**FOURTH LINE WELL FIELD EXPANSION, ACTON, MUNICIPAL CLASS ENVIRONMENTAL ASSESSMENT  
STUDY – PROJECT FILE**

Appendix C External Agency Comments  
January 21, 2015

## CVCA Comments Review Presentation and Discussion

# Environmental Impact Assessment Fourth Line Well Field

## Hydrogeological Response 4

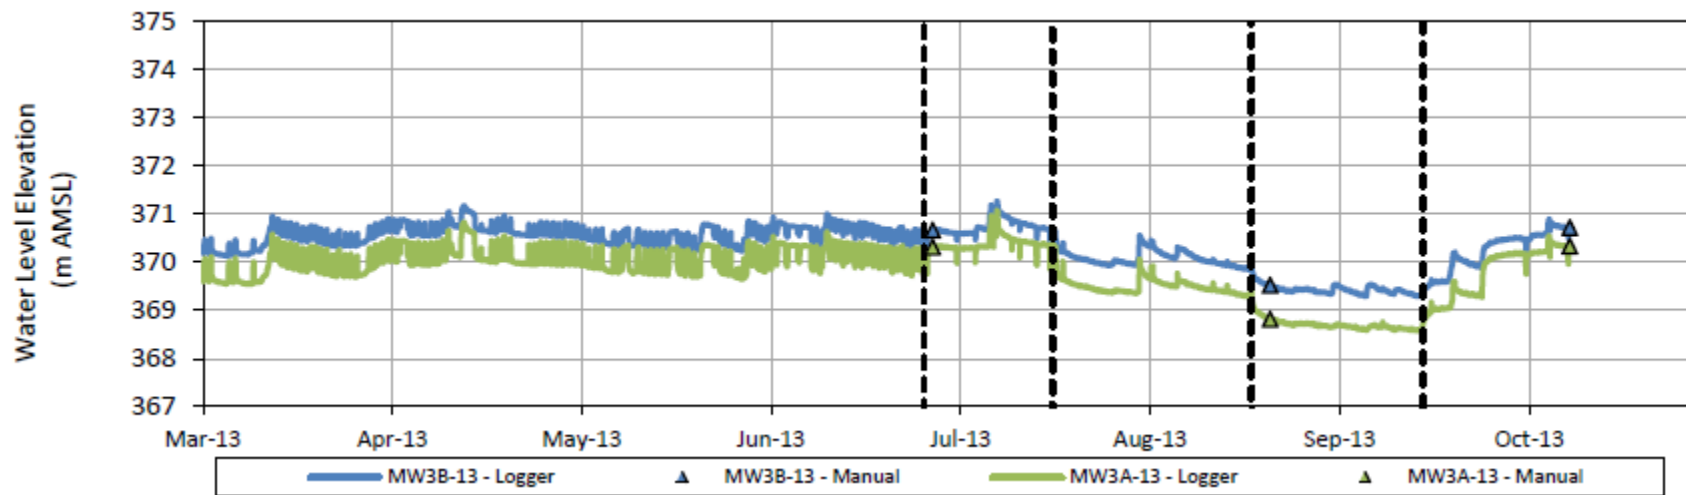
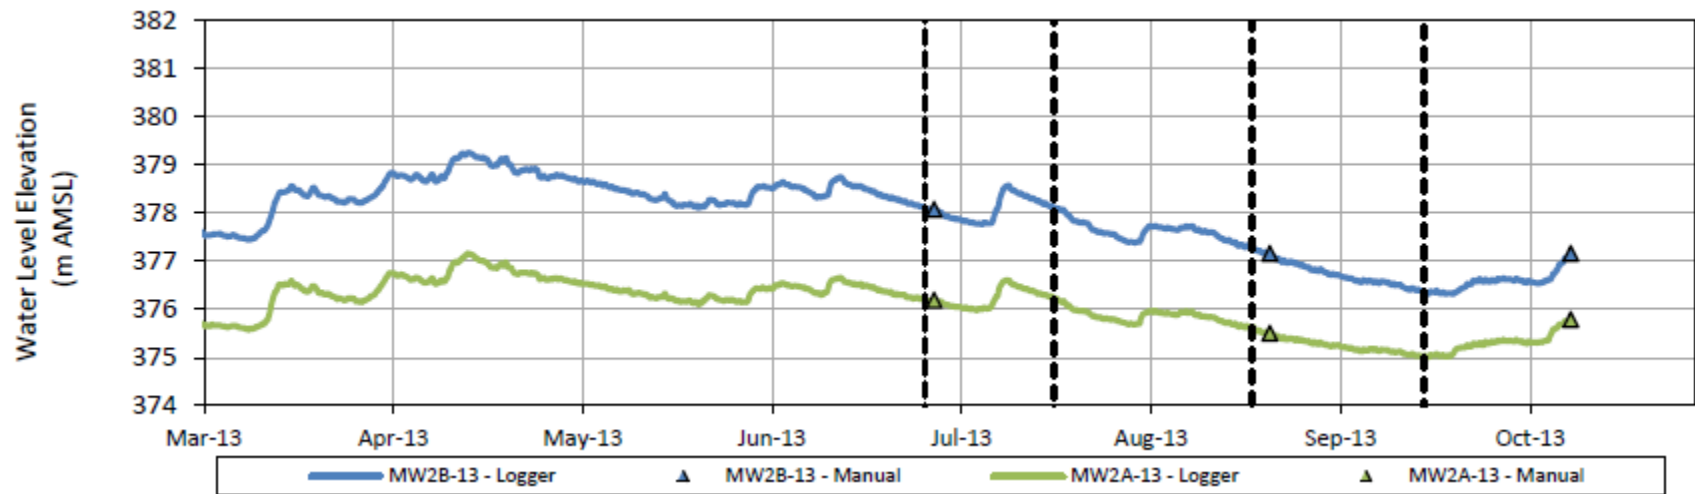
### **Response to CVCA Comment 4 – About Station (MP5)**

Stantec discussed the data for this station and how the aquifer showed ideal response to the pumping.

Stantec interprets the overburden response as being unrelated to pumping response.

Hydrogeological Response 5

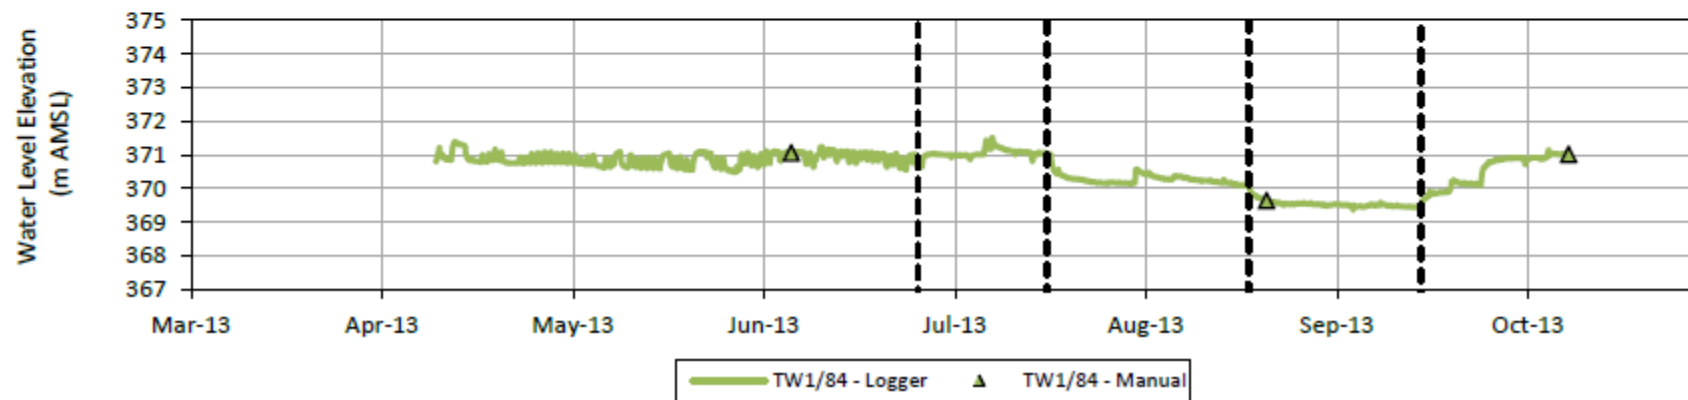
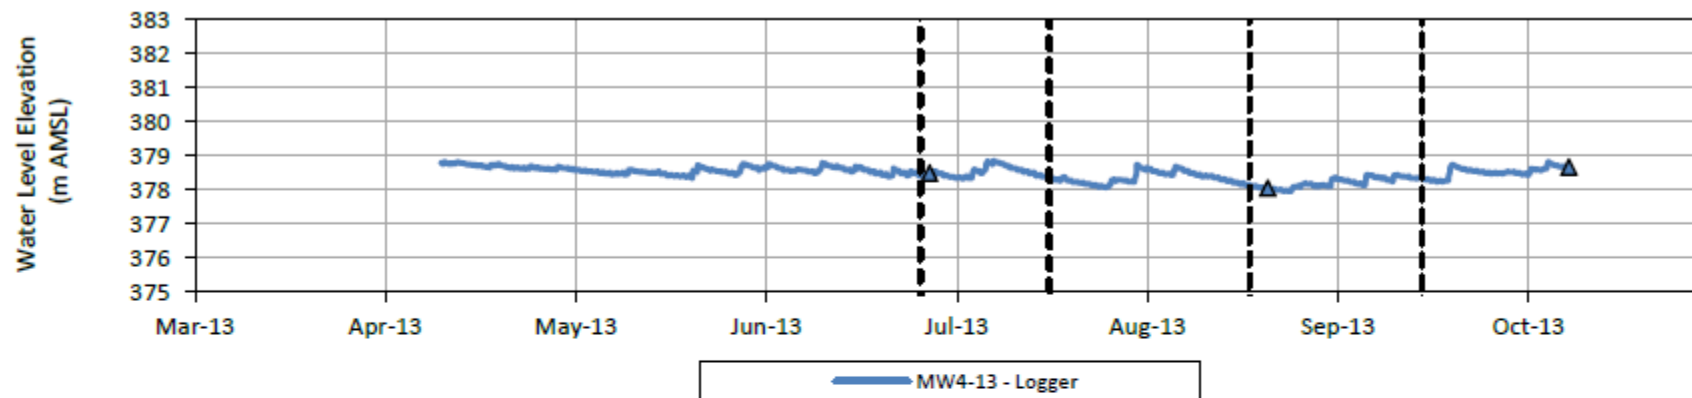
### **Response to CVCA Comment 5 – About Stations MW2B & 3B**

Station 3B shows a characteristic response versus Station 2B not showing a response.
